CRITICAL ANALYSIS OF DAVIS/ MOON 2015 PRESENTATION ON PARTICLE BOARD CABINET THICKNESS SWELL

6-25-18

Peer Reviewers. Reviewers Of Our Critique of Moon 2015

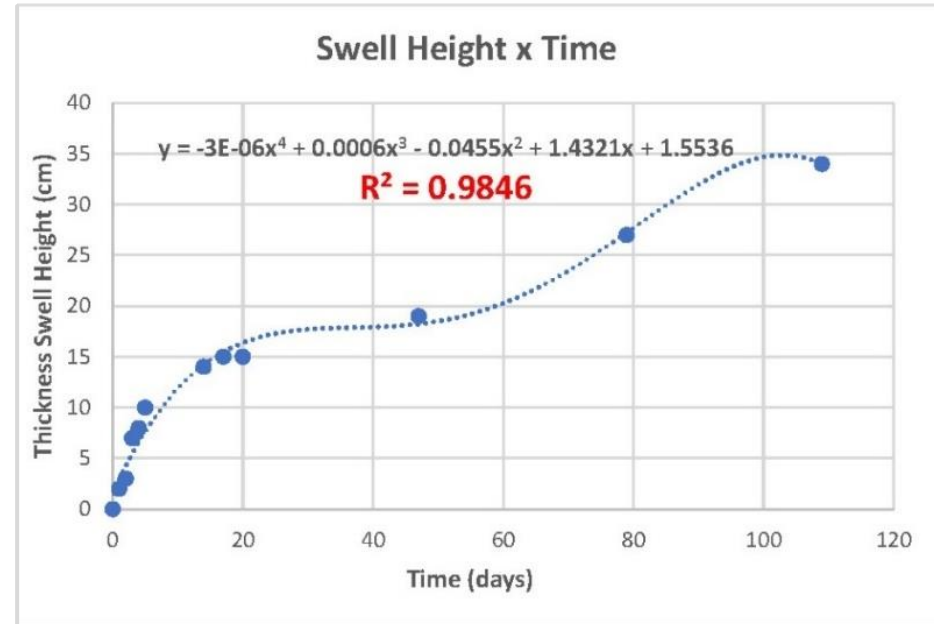
- Here we have redone the regression analysis using a non-linear function ... same data.
- We get $R^2=0.9846$ which is an awesome fit both mathematically and visually the “line” fits the points.
- Clearly the data is not linear.
